**DUKE POWER COMPANY**

November 1, 1982

Re: McGuire Nuclear Station  
Docket Nos. 50-369, 50-370

Attached are responses to concerns related to NUREG-0612, Control of Heavy Loads at Nuclear Power Plants. Attachment 1 contains responses to the draft technical evaluation report which was transmitted by Elinor G. Adensam's letter of September 9, 1982. Attachment 2 contains the results of an evaluation of load handling operations in the spent fuel pool areas as requested in Section 2.2 of Enclosure 3 to the generic letter of December 22, 1980. Attachment 3 contains the results of an evaluation of load handling operations in the Auxiliary Building as requested in Section 2.4 of Enclosure 3 to the generic letter referenced above.

Figure 9.1.2-1A (1 of 3)

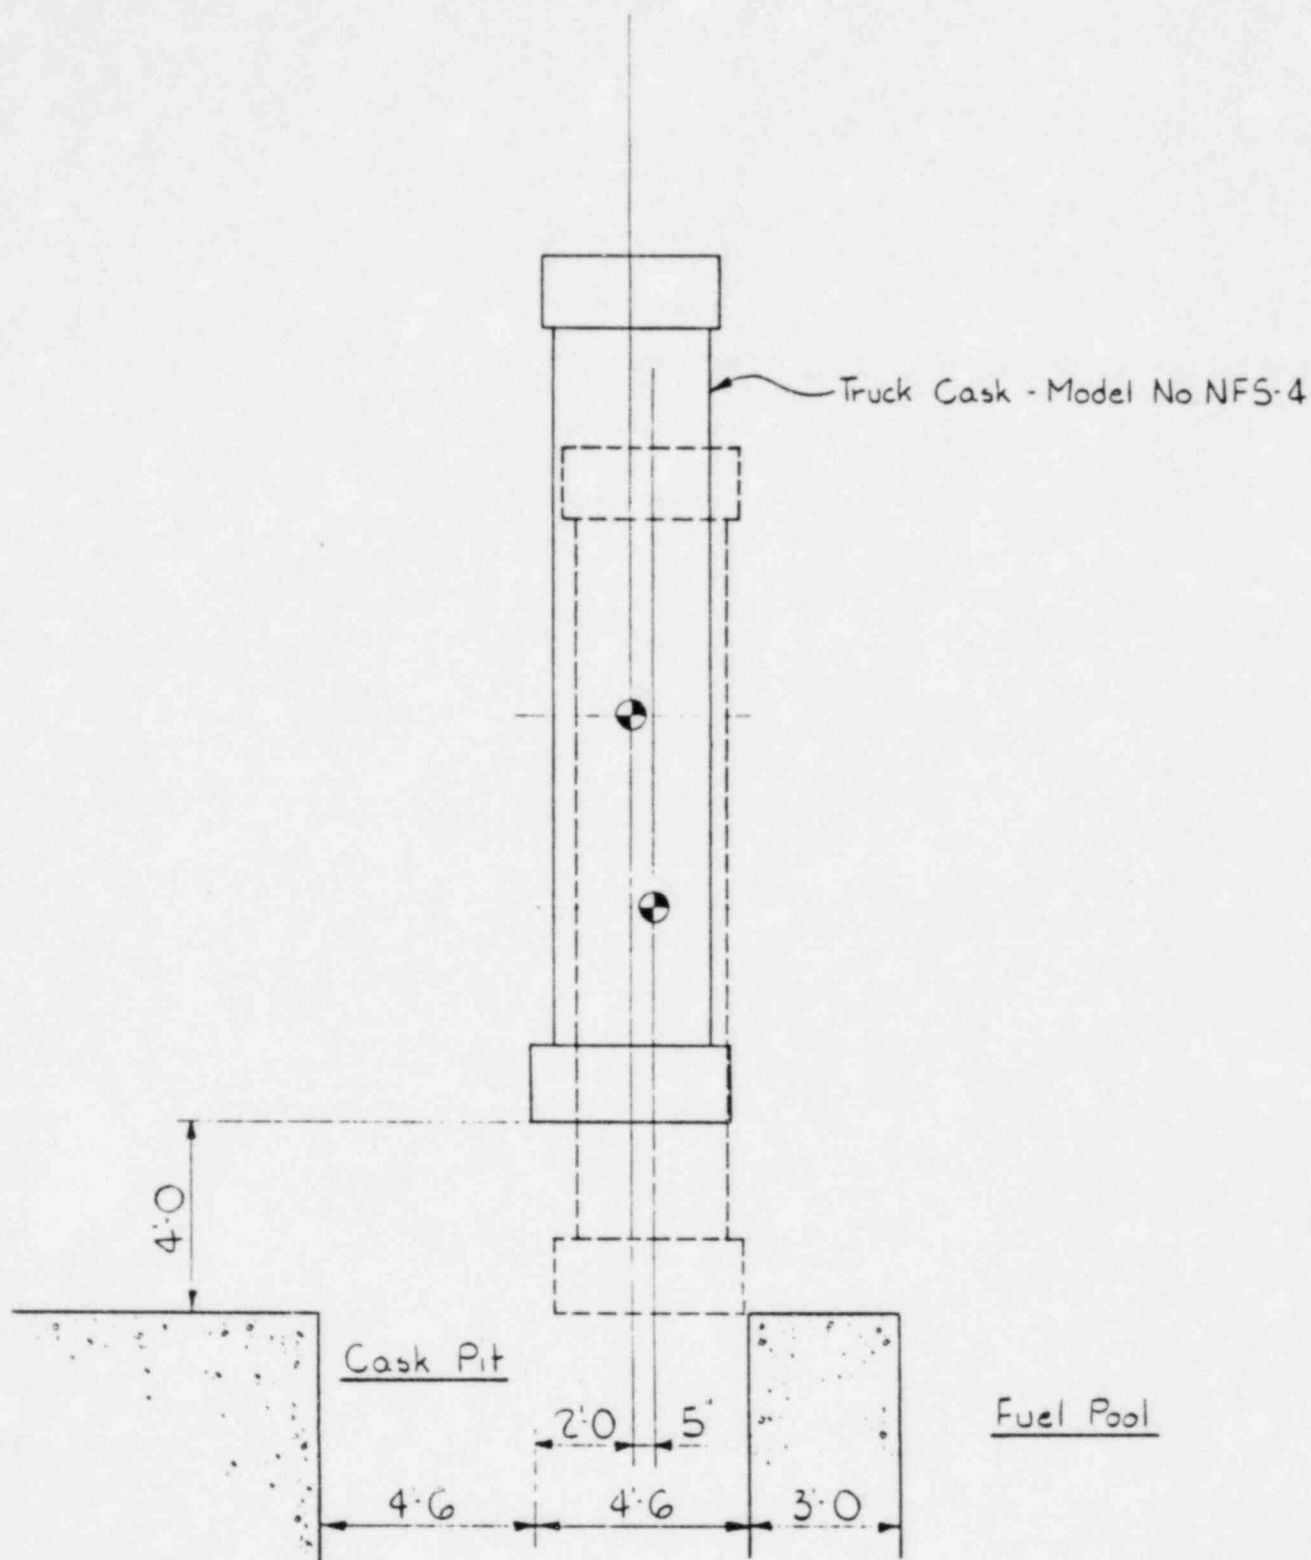
Case #1 - The cask handling crane is assumed to be traveling at its maximum speed of 50 fpm and hits the crane stops nearest the spent fuel pool. The crane stops, and the cask is assumed to continue traveling toward the spent fuel pool rotating about a line through the centerline of the crane drum. The cask continues to swing until the kinetic energy is completely converted to potential energy (i.e. the cask raises up as it rotates about the crane drum). At the instant the cask swings as close to the spent fuel pool as possible, the cable breaks and the cask falls. The conclusion is that the cask falls on the edge of the spent fuel pool wall and falls away from the spent fuel pool due to its center of gravity being behind the wall. See Figure 9.1.2-1A (1 of 3) for an illustration of this case.

Figure 9.1.2-1A (2 of 3)  
Revision 38

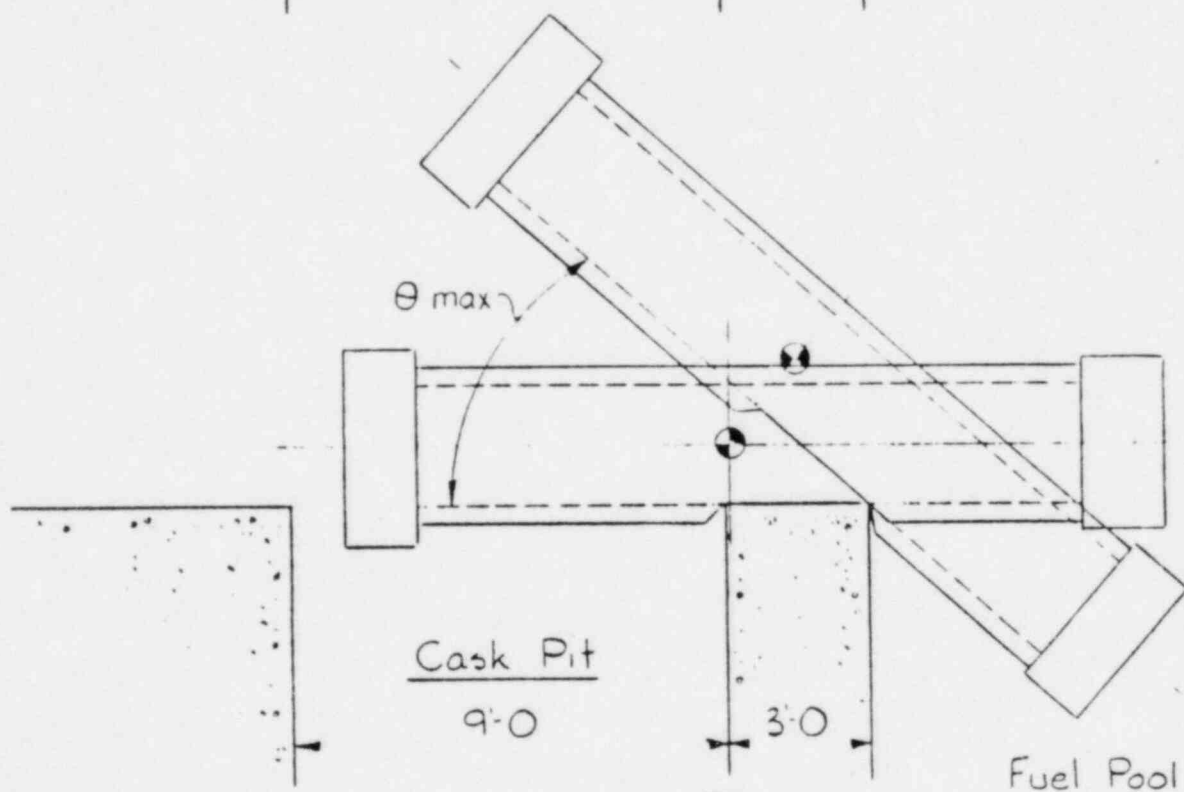
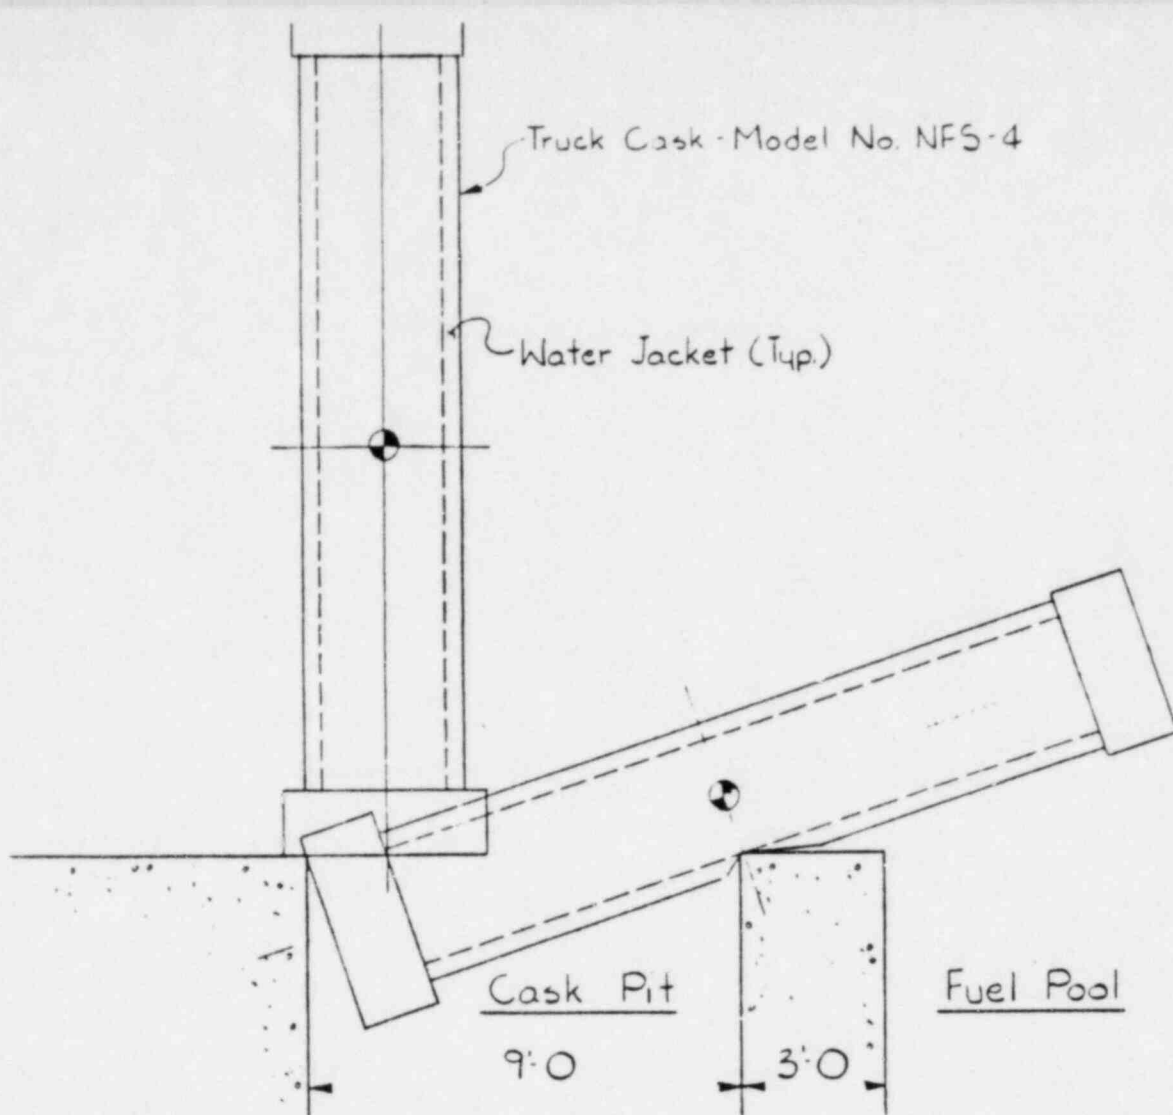
Case #2 - The cask handling crane is assumed to be traveling at its maximum speed of 50 fpm and hits the crane stops nearest the spent fuel pool. The crane stops and the cable breaks at the same instant, therefore the cask does not swing but is moving at 50 fpm. The cask is assumed to be at its highest position, which is approximately 4 feet off the floor. The distance the cask travels at 50 fpm in the time it takes for the cask to fall 4 feet is determined and it is concluded that the cask will not hit the spent fuel pool wall but will fall directly into the cask pit. See Figure 9.1.2-1A (2 of 3) for an illustration of this case.

Figure 9.1.2-1A (3 of 3)  
Revision 38

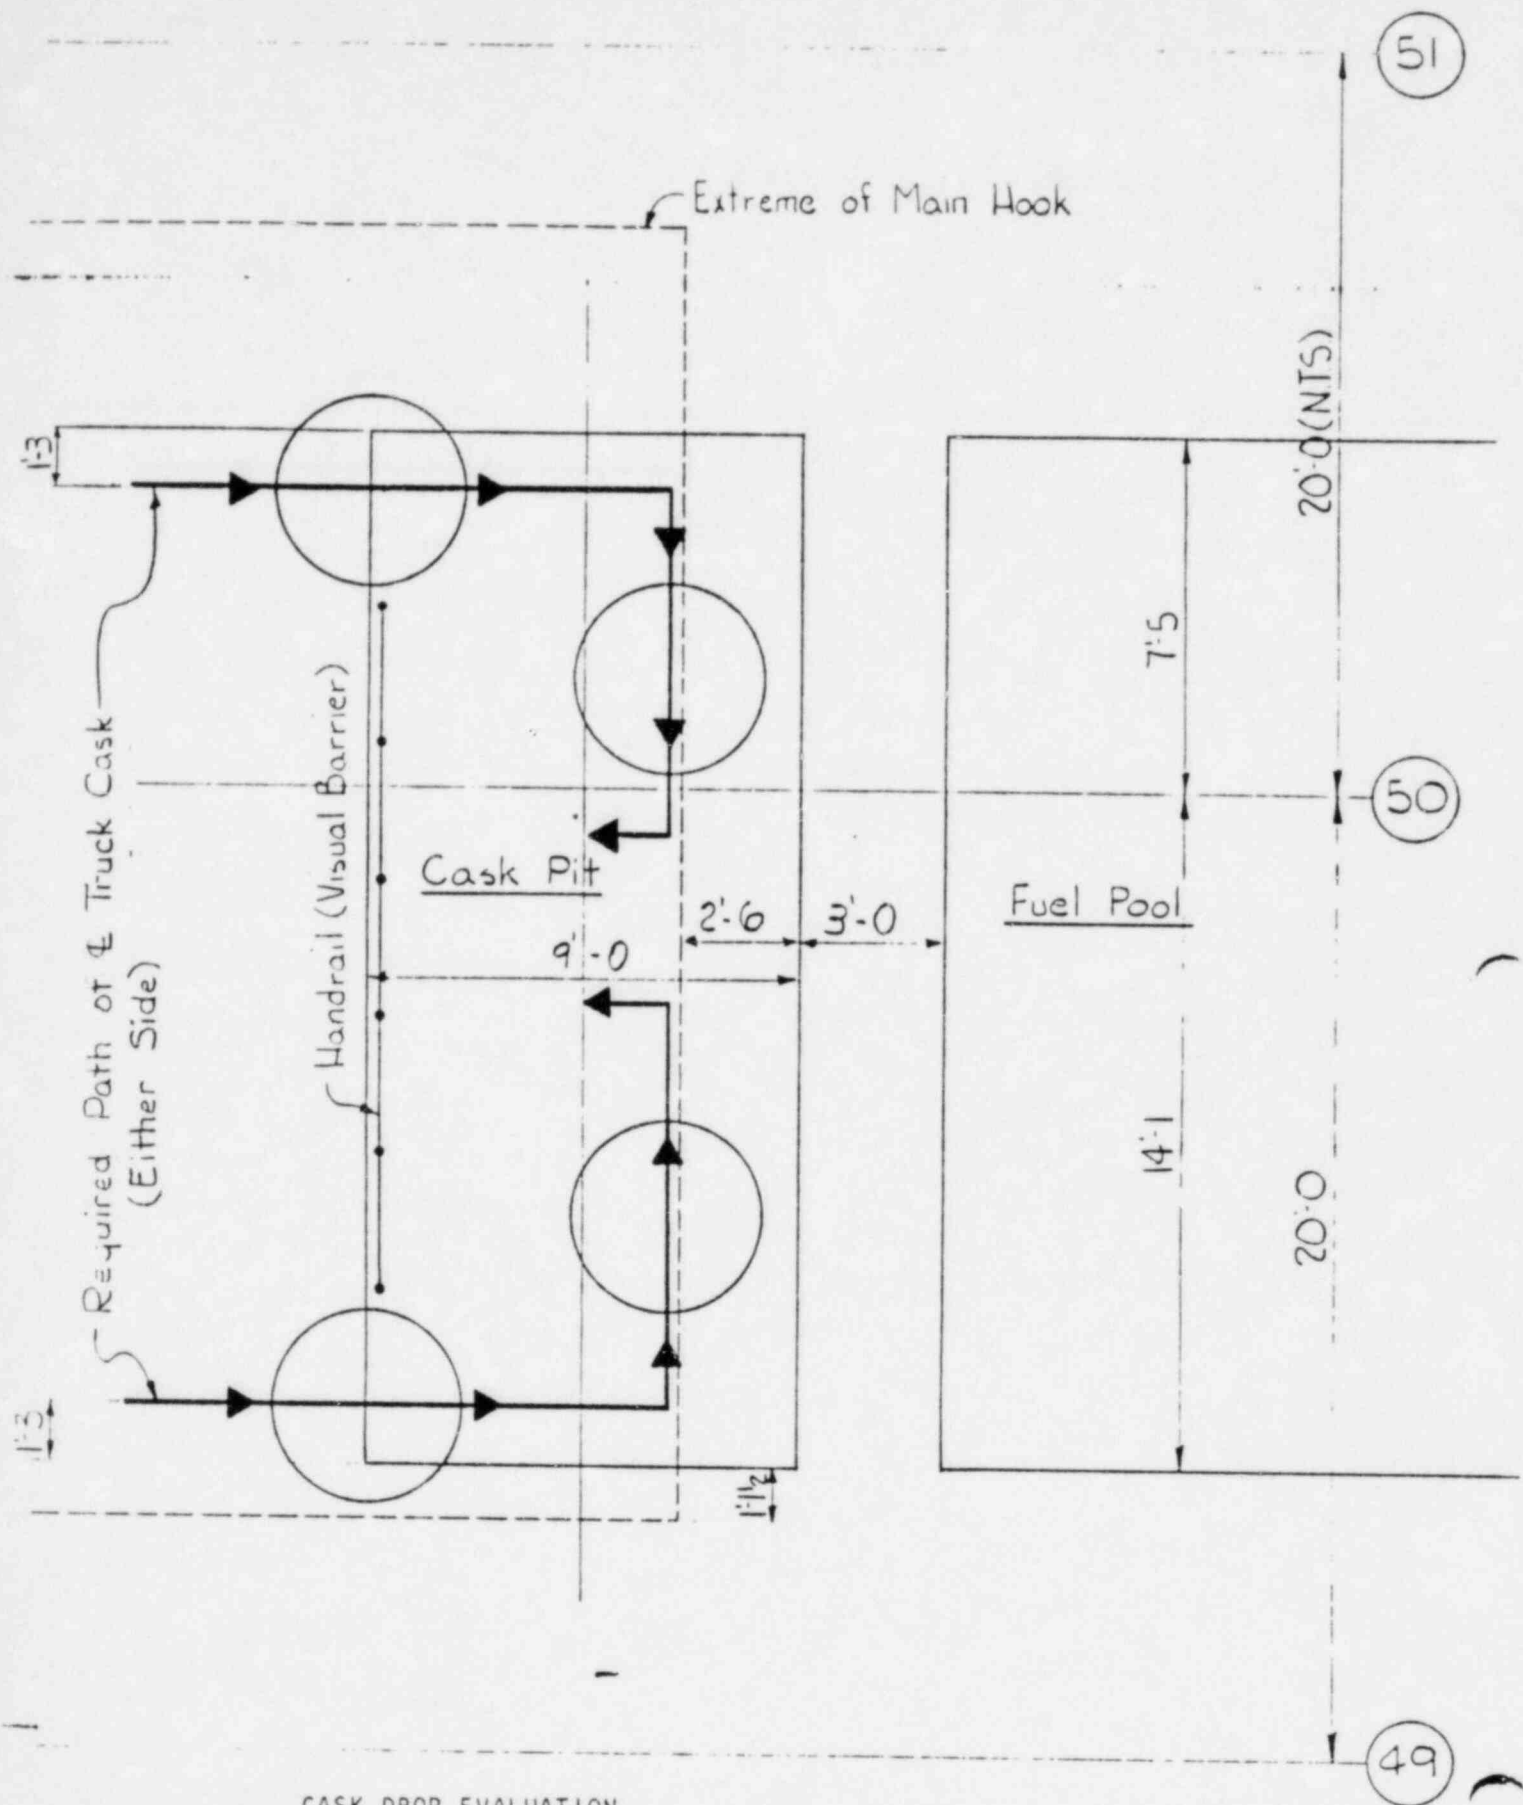
Case #3 - The cask is assumed to be over the edge of the cask pit wall and the cable breaks. The cask either drops on the edge of the wall or the cask is lowered on to the edge of the wall. Either case gives the same initial conditions because in the event of a drop the kinetic energy is assumed to be absorbed by the cask's bottom energy absorber, as stated in the Safety Analysis Report for the cask. Therefore, the cask's potential energy will cause the cask to tip toward the spent fuel pool wall. Energy losses at impact with the spent fuel pool wall are conservatively considered and the results of the analysis show that the remaining energy is not sufficient to cause the cask to fall into the spent fuel pool. See Figure 9.1.2-1A (3 of 3) for an illustration of this case.
